LAKE NONA TOWN CENTER PHASE 2A

LAKE NONA TOWN CENTER PHASE 2

SUMMARY

EXHIBIT D: PEDESTRIAN AND BIKE PATHS

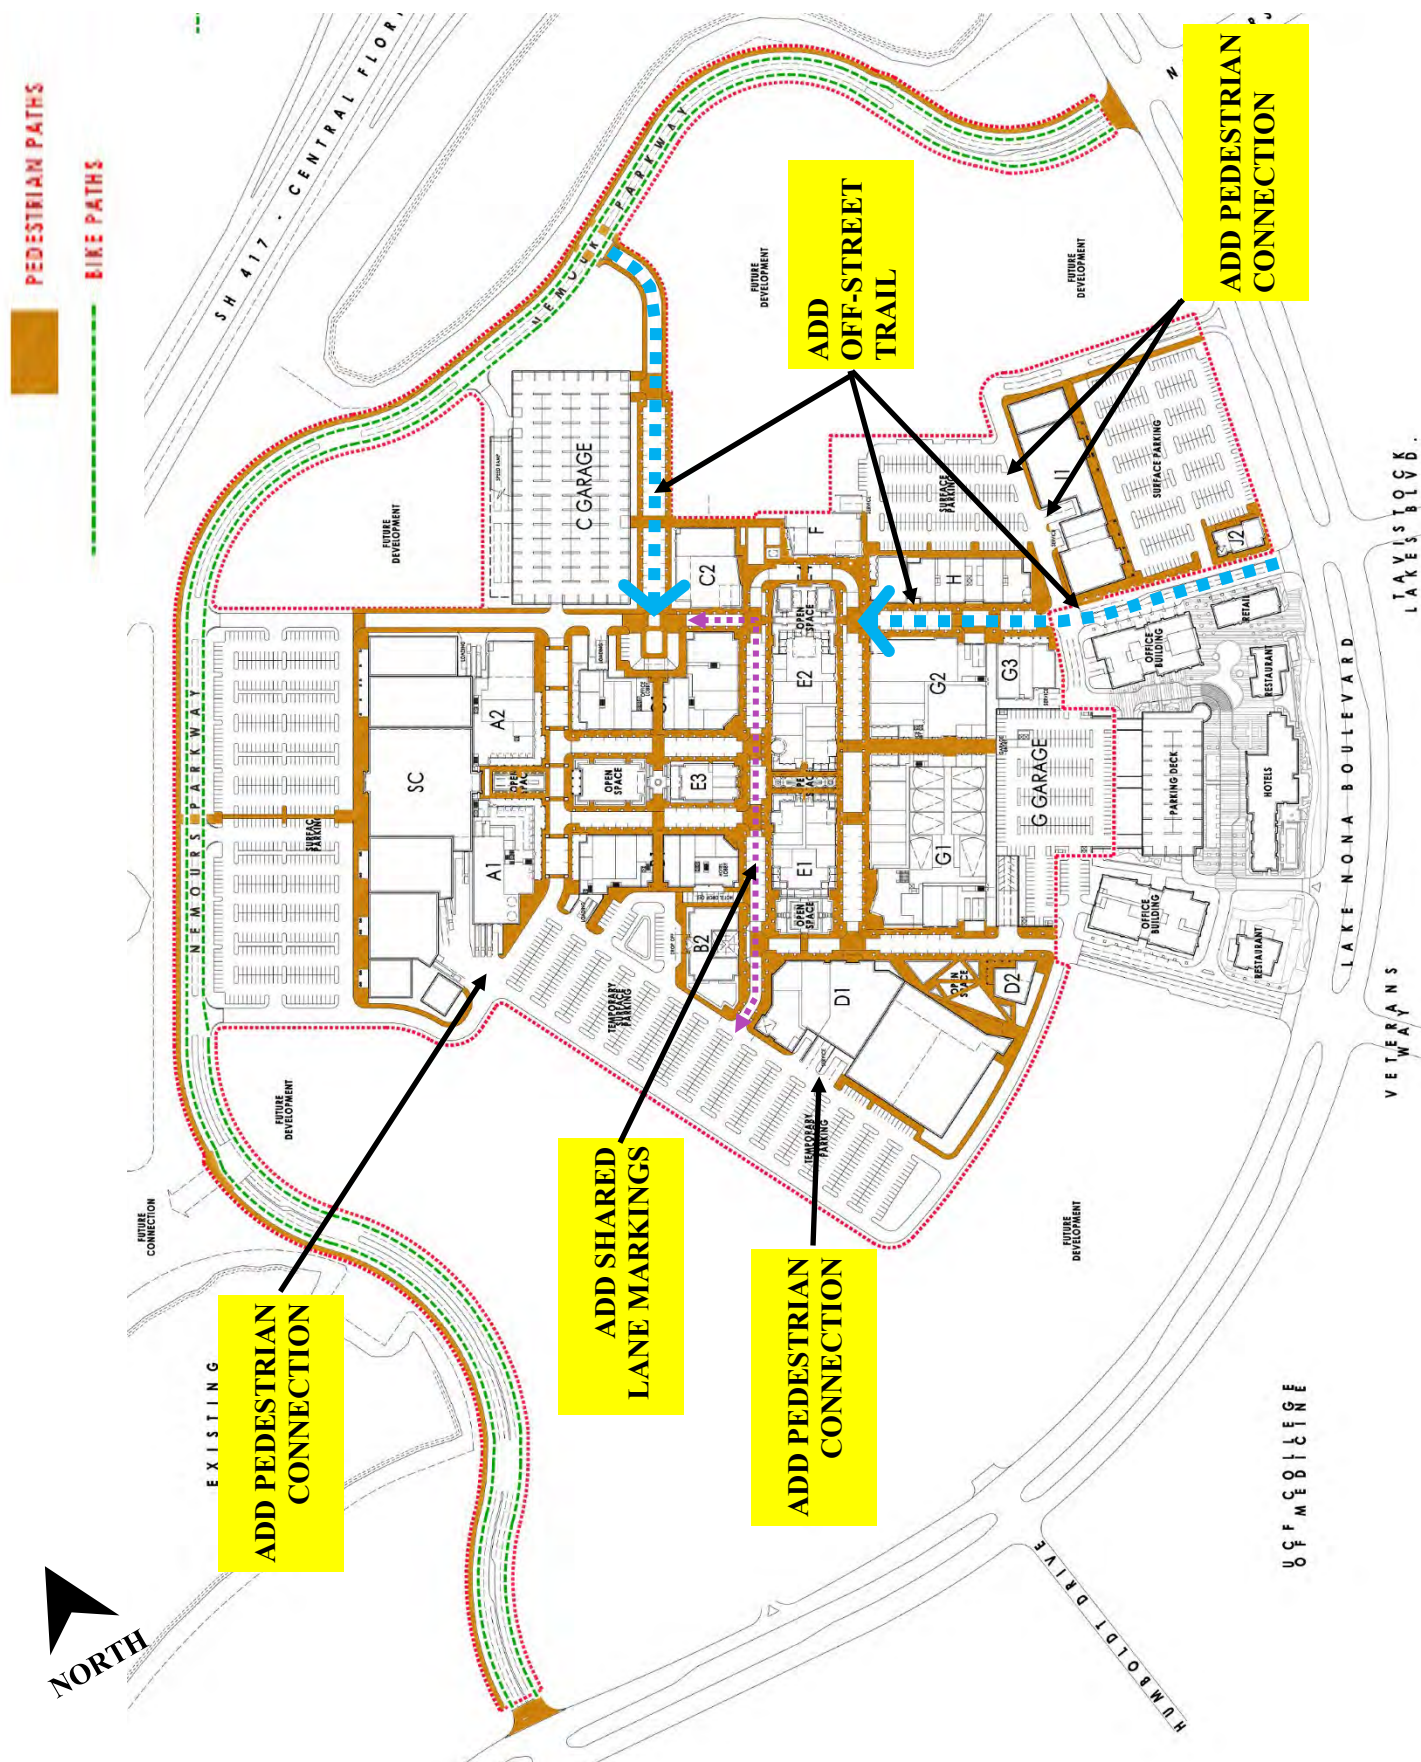
Page 15 shows the subject proposal's pedestrian and bicycle pathways. The pedestrian connections are substantial as most blocks are shown to have complete pedestrian connections bordering four sides with interconnections between them. According to the Southern Circulation Plan (case #MPL2011-00004, see **Figure 1**), an "Enhanced Pedestrian Path" should continue from Tavistock Lakes Blvd across Lake Nona Blvd and continue through the core of the Town Center. The existing enhanced pedestrian path along Tavistock Lake Blvd is a 10 ft. multi-use trail that terminates at the Town Center entrance on Lake Nona Blvd. The conditions of approval require an enhanced connection through the core of the Town Center.

The proposed plan shows a dual use facility extending from Tavistock Lakes Blvd through Lake Nona Blvd and into the core of the Town Center. Where this facility terminates, inside the core, substantial bike amenities, such as a bicycle station, should be provided. The minimum required width of a dual use facility is 10 feet, however the conditions of this report will allow for an 8 foot wide facility.

The applicant shall construct a minimum 8 foot wide off-street trail (add 2 feet for “door swing zone” where adjacent to street parking) from the intersection of Lake Nona Boulevard and Tavistock Lakes Boulevard along the north side of the access road adjacent to buildings J2, J1, and H to a terminus at the core of the Town Center. This is in addition to the required 8 feet wide pedestrian clear zone. Color and/or pavement treatment should clearly differentiate the off-street trail from pedestrian clear zone. Pavement markings/symbols to signal the separation of pedestrians from bikes, rollerblades, skateboard, etc. should also be included.

The applicant shall construct a minimum 8 foot wide off-street trail (add 2 feet for “door swing zone” where adjacent to street parking) from the intersection of Nemours Parkway and the "Garage C" access road to the southern edge of "Garage C". This is in addition to the required 8 feet wide pedestrian clear zone. Color and/or pavement treatment should clearly differentiate the off-street trail from pedestrian clear zone. Pavement markings/symbols to signal the separation of pedestrians from bikes, rollerblades, skateboard, etc. should also be included.

EXHIBIT F: ROAD TYPES (MAP)

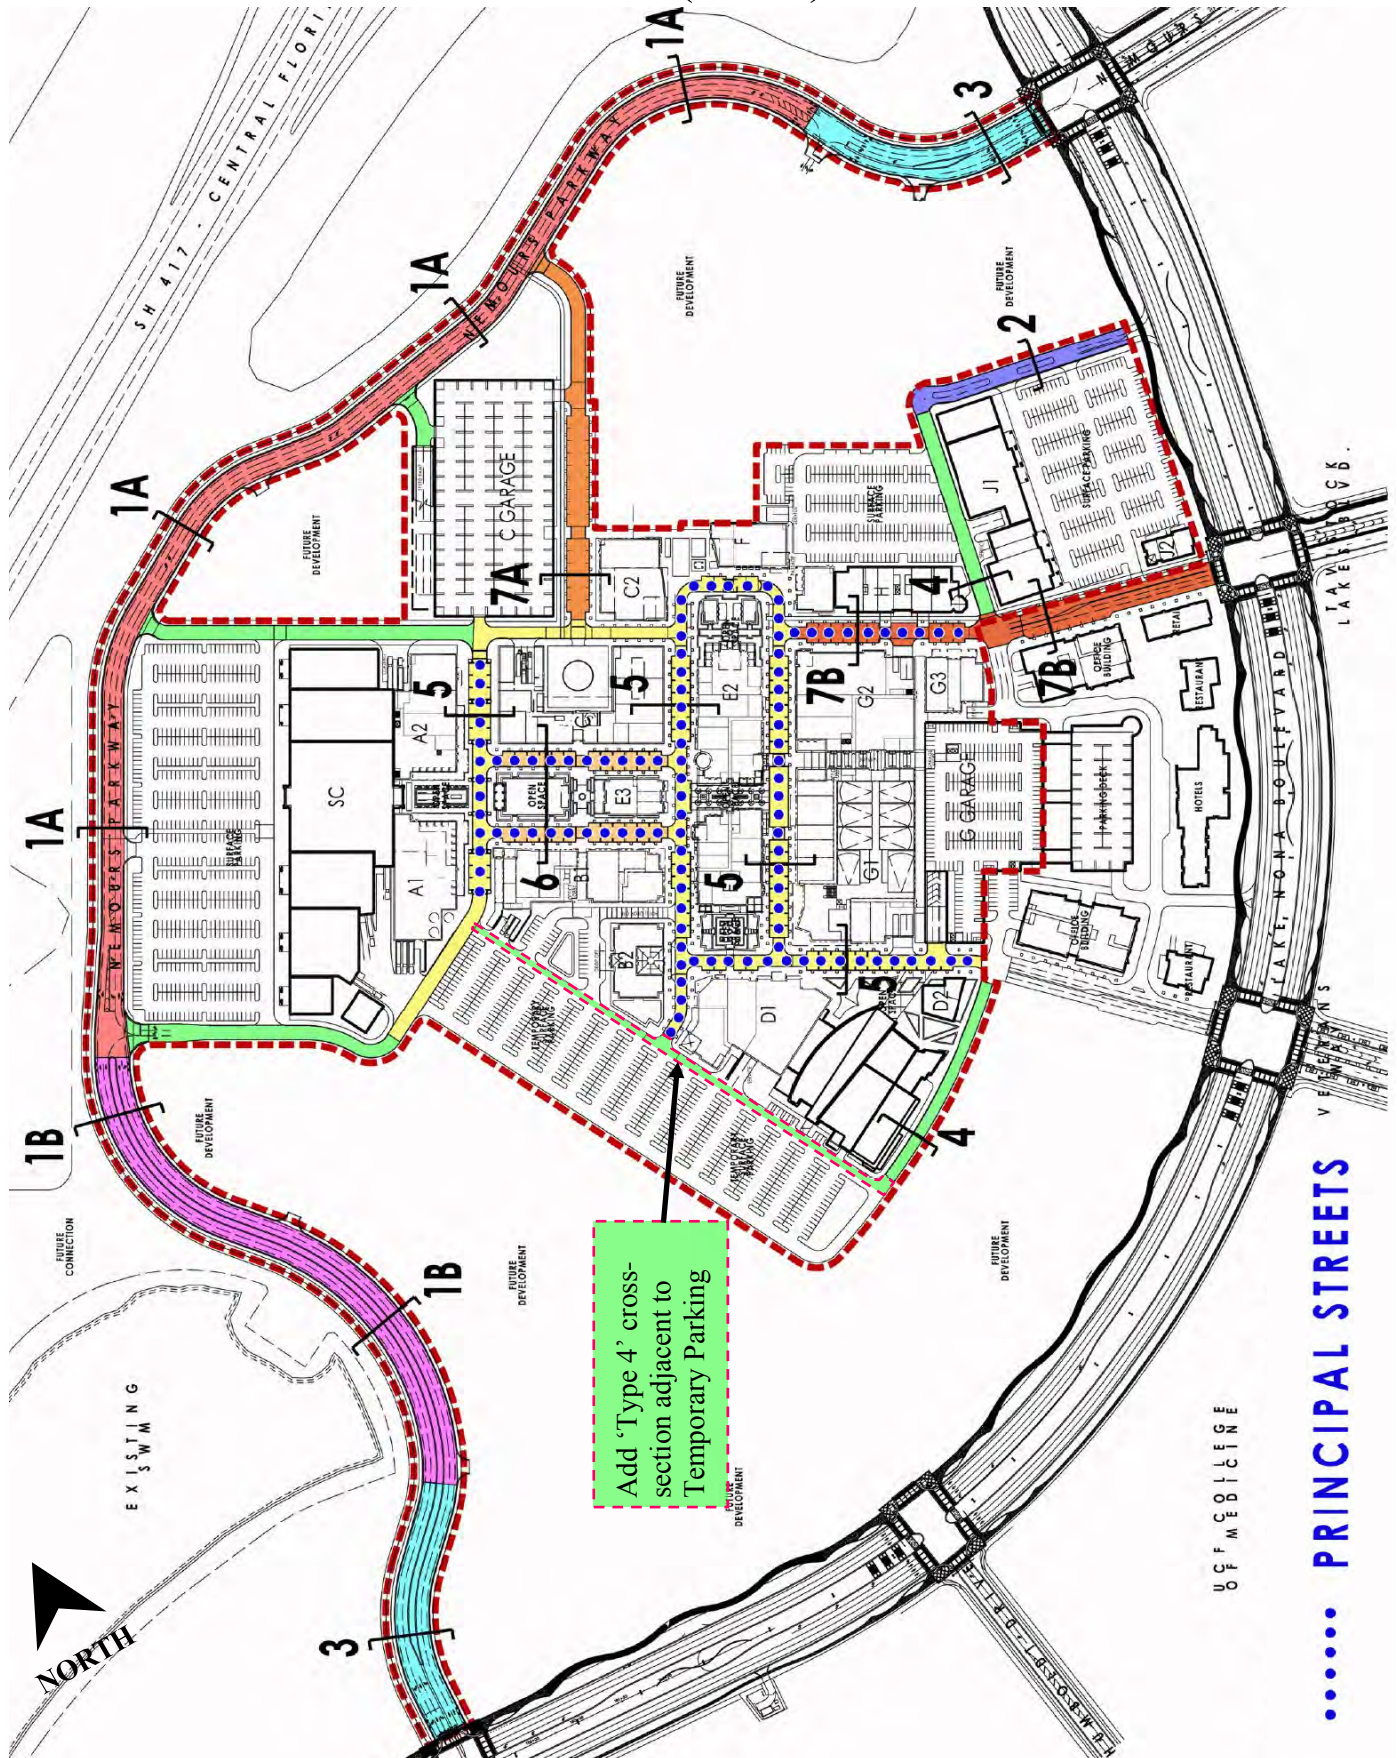
The internal streets should be considered “local roads” as described in LDC Chapter 68, which specifies a maximum travel lane width of 10 feet. The street types shown on **Pages 19-20** propose local road travel lane widths of between 11 and 15 feet. In order to achieve adequate traffic calming, foster pedestrian safety, and maintain smooth traffic operations, staff recommends that lanes widths not exceed 10 feet except where a higher incidence of delivery truck traffic is presumed in which up to 12 foot wide lanes are permitted (**Page 16** shows vehicle circulation and service areas). With the expectation of future development, the ‘Type 4’ cross section should be used along the Temporary Parking area, adjacent to Buildings B1, B2, and D1.

Type 4 cross-section—With the expectation of future development, the ‘Type 4’ cross section should be used along the street adjacent to Buildings B1, B2, and D1. The streetscape for street Type 4 shall be built on the side adjacent to the buildings, but the other side may be designed as a drive aisle, to be upgraded in a future phase.

EXHIBIT F: LOOP ROAD TYPES (SECTIONS)

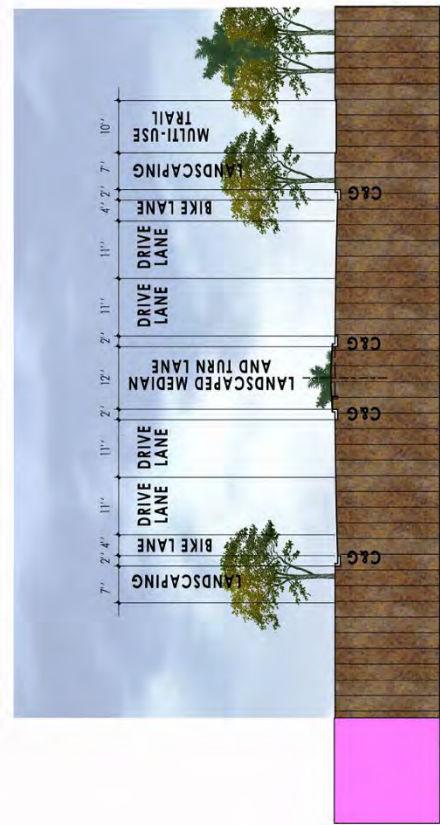
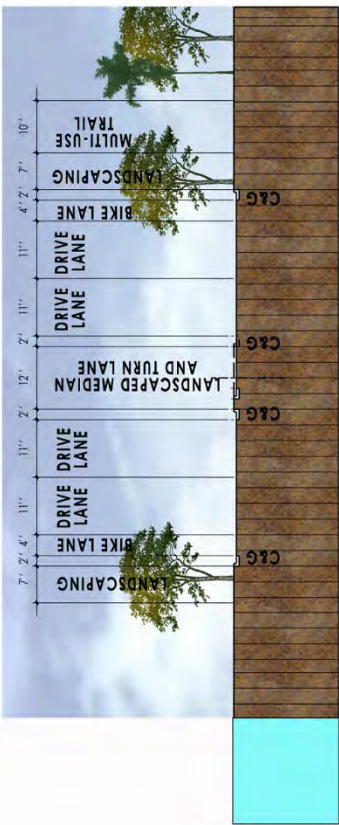
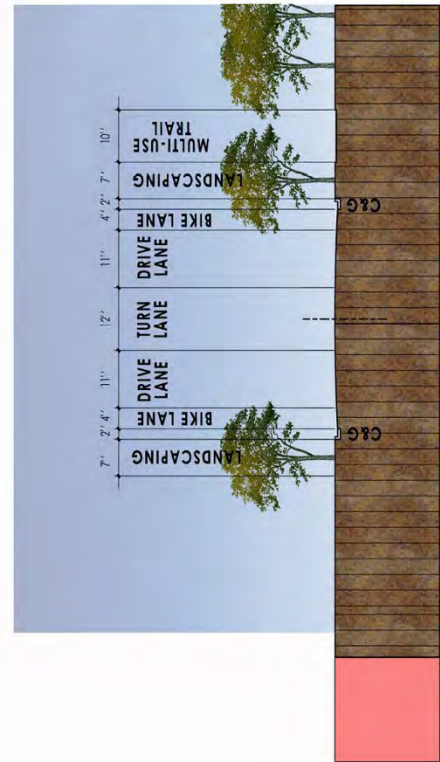
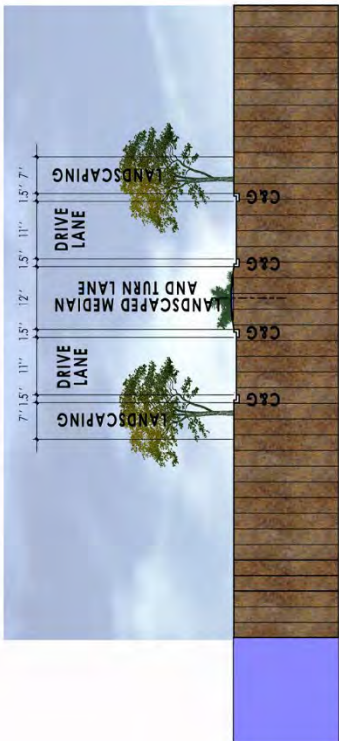
According to LDC Chapter 68, Town and Village Center streets should be composed of arterial and local streets. The subject proposal includes a “Loop Road” (as shown on **Pages 17 and 18**), a public arterial road that will be constructed by the developer and maintained by a Community Development District (CDD). The proposed road is the westward extension of Nemours Parkway, following along the perimeter of the Town Center, bending south and intersecting with Lake Nona Blvd for a second time (west of the UCF College of Medicine). The loop road will carry the Nemours Parkway name through to the “future extension” (indicated on the plans), at which point will be required to change names in order to prevent two intersections of Nemours Parkway with Lake Nona Boulevard. If the future extension intersection requires more than multiway stop control, staff prefers that a roundabout be installed at this location rather than a signalized intersection. Raised medians will be required at multiple intervals around the loop road in order to promote traffic calming. **Pages 17-20** identify seven street types; three for the loop road and three for the internal streets. The loop road shall have a minimum right-of-way of 75 feet to accommodate two 5 foot bicycle lanes, 2 foot curb and gutters on each side, a 10 foot wide share-use path on the north/west side, two 7 foot wide landscape buffers, two 10 foot travel lanes, and a 12 foot wide center turn lane/raised median.

Add transportation changes—Add ‘Transportation Planning conditions’ #2-6 and ‘Transportation Engineering conditions’ #3-7. Update cross-sections.

EXHIBIT G: BLOCK NUMBERS

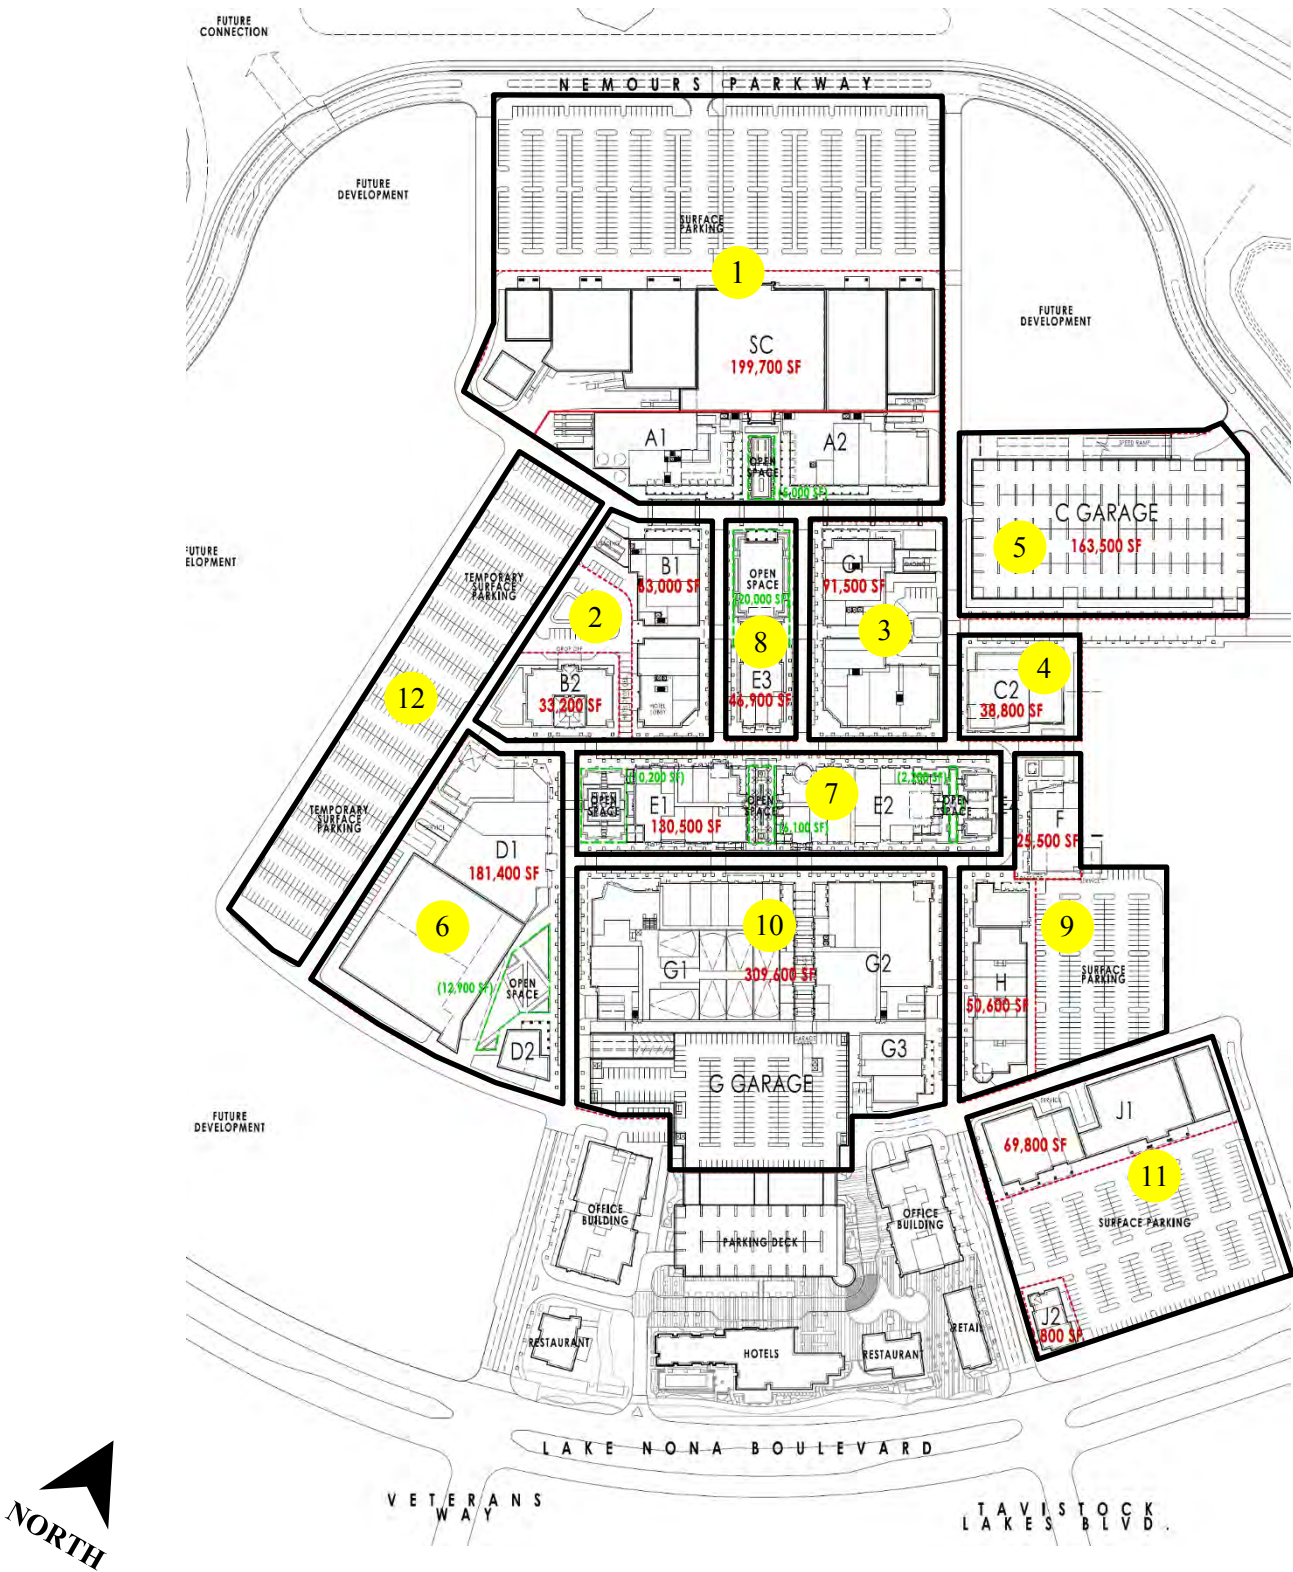
The Temporary Parking lot indicated as “Block 12” on Page 21 is permitted for a maximum of 5 years from the date of permit issuance. An extension of this time horizon requires approval from the SETDRC.
